UNITED STATES PATENT AND TRADEMARK OFFICE

APPLICATION NO.	FILING DATE	FIRST NAMED INVENTOR	ATTORNEY DOCKET NO.	CONFIRMATION NO.
09/977,154	10/12/2001	Hugh S. West JR.	14000.11	3848

Office Action Summary

DETAILED ACTION

FIG. 4

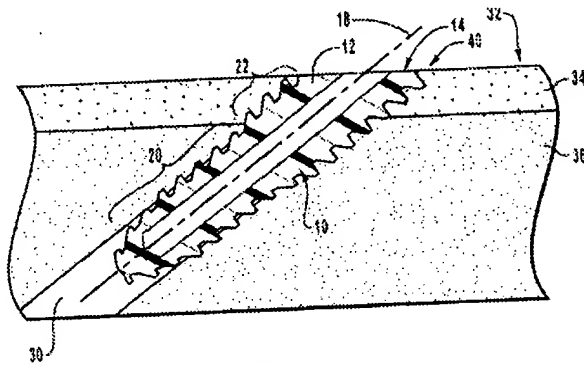
The drawings are objected to as failing to comply with 37 CFR 1.84(p)(4) because reference character "22" has been used to designate different portions as the "proximal section" in Figures 2 and 4. Corrected drawing sheets in compliance with 37 CFR 1.121(d) are required in reply to the Office action to avoid abandonment of the application. Any amended replacement-drawing sheet should include all of the figures appearing on the immediate prior version of the sheet, even if only one figure is being amended. The replacement sheet(s) should be labeled "Replacement Sheet" in the

Claims 1-18, 20-21 and 23-34 are rejected under 35 U.S.C. 112, first paragraph, as failing to comply with the written description requirement. The claims contain subject matter that was not described in the specification in such a way as to reasonably convey to one skilled in the relevant art that the inventor(s), at the time the application was filed, had possession of the claimed invention. Note comments above. Also, in Figure 4 (Applicant's disclosure), the proximal and threaded sections could be as illustrated below, making the distal and proximal threaded sections about equal in length.
